Marine Drive, Valley and Canal Community Council

DATE: June 20, 2011

SUBJECT: **Case 15969: Development Agreement for an Open Space Subdivision
at 156 Windgate Drive, Windsor Junction**

SUBJECT: **Case 15969: Development Agreement for an Open Space Subdivision at 156 Windgate Drive, Windsor Junction.**

Windgate Farm Subdivision
Drainage Plan
Concept Plan of Lands of
Powder Mill Developments Ltd.
 Beverbank and Windsor Junction Crossroads
 P.I.D. 00510628 and 40280810
 Windsor Junction, Halifax Regional Municipality
 Province of Nova Scotia

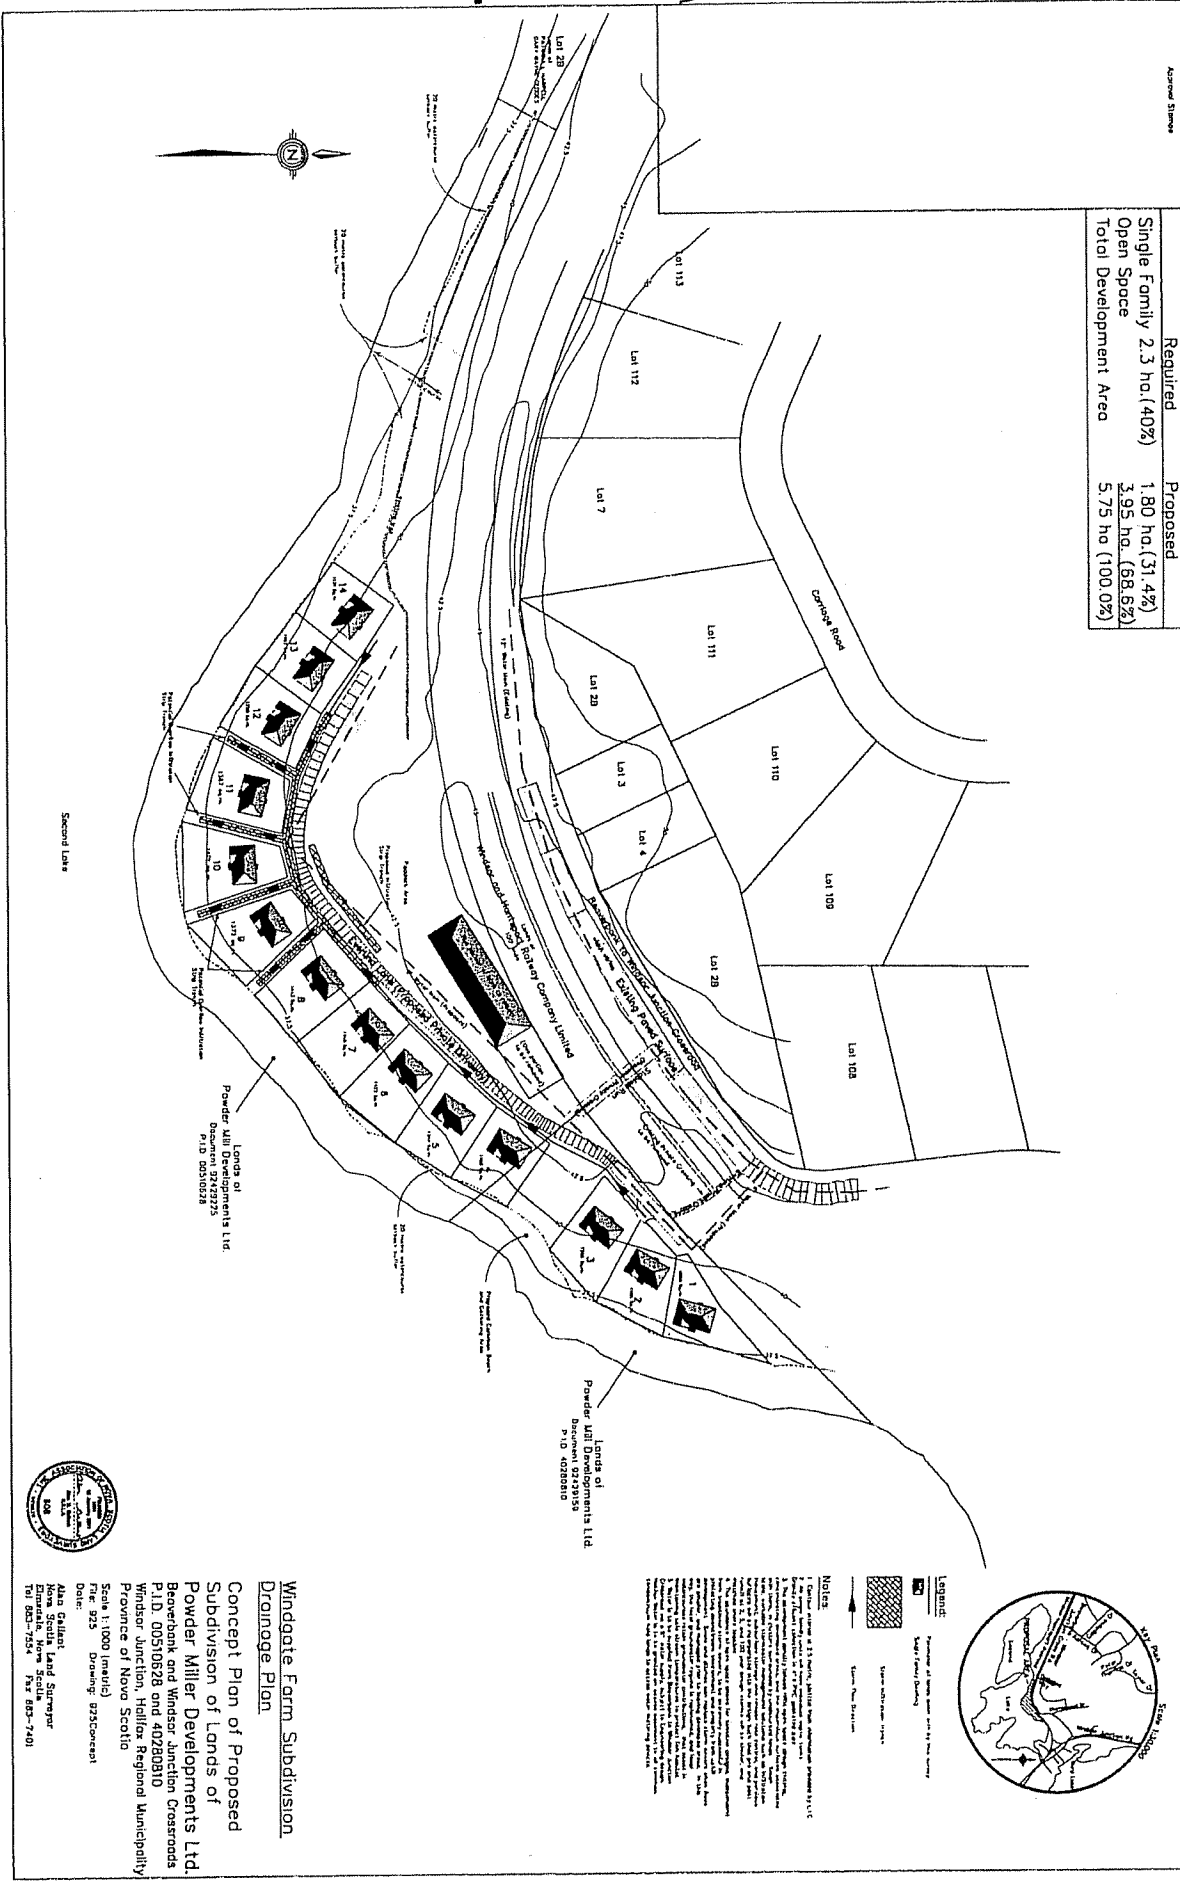
1. The condominium design should consider capturing LEED credits for reduction of water consumption.
2. Soil testing be done for contamination at the barn/manure pile site and at sites proposed for the infiltration ditches.
3. Baseline testing of the water be conducted at designated locations in Second Lake.
4. HRM staff review the Condominium Corporation's by-laws for compliance with water protection.
5. A non-disturbance area be included in the Development Agreement.
6. A sedimentation and erosion plan be established.
7. A minimum mandatory bonding of \$10,000 per acre be required.
8. Oil not be used for home heating (impact on lake if oil spill).
9. Testing be conducted to rule out the presence of acidic slate.
10. The common area next to the lake be landscaped and reforestation efforts continued.

- the sandy/silt soil composition
- the proposed source of heating for the condos
- drainage and infiltration through the trenches
- monitoring of household water use
- whether horses will remain on the site and how this will be managed
- bonding and securities
- the role of the Condominium Corporation
